Memorandum

DATE: September 13, 2017

SUBJECT: Office of Planning Report for Large Tract Review Case No. 2017-04
72 Florida Avenue, N.E. (Square 3518, Lots 816)

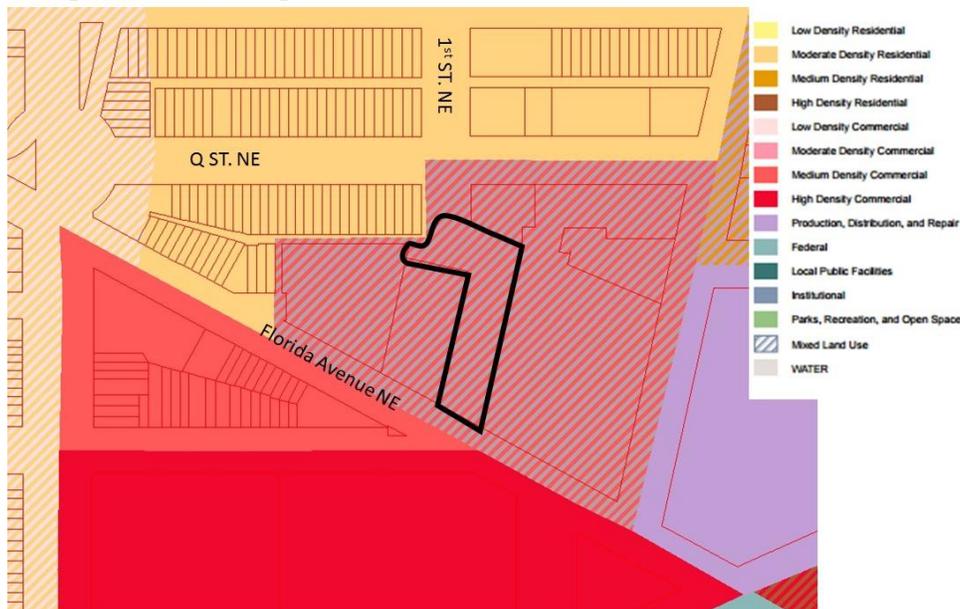
- Pull the building up to Florida Avenue to improve its orientation with the pedestrian environment.
- Add streetscape activating and employment generating retail, maker space, or artist space on the ground floor.
- Add more windows to the ground level to improve its attractiveness to the pedestrian environment.
- Locate building signage to the ground level to improve its attractiveness to the pedestrian environment.
- Increase the landscape area.

Another issue is that the proposed mural on the front façade facing Florida Avenue would be out of character with the character for the area. No other building has a mural in the front. Typically, murals are on the side of buildings. The Commissioner expressed that windows or something else should replace the mural in order to have the building better fit in with the surrounding development.

Vehicular and truck access is proposed from two curb cuts – one on Florida Avenue and one on 1st Street, immediately adjacent to a public alley (see Figure 1). The site design results in no back-up maneuvers in public space. The Florida Avenue curb cut consolidates two non-standard curb cuts into a single 24-foot curb cut to be shared with the adjacent property to the west (owned by XM Investment

OP forwarded these recommendations to the applicant and the applicant has agreed to include them as much as possible in the building's design and programming.
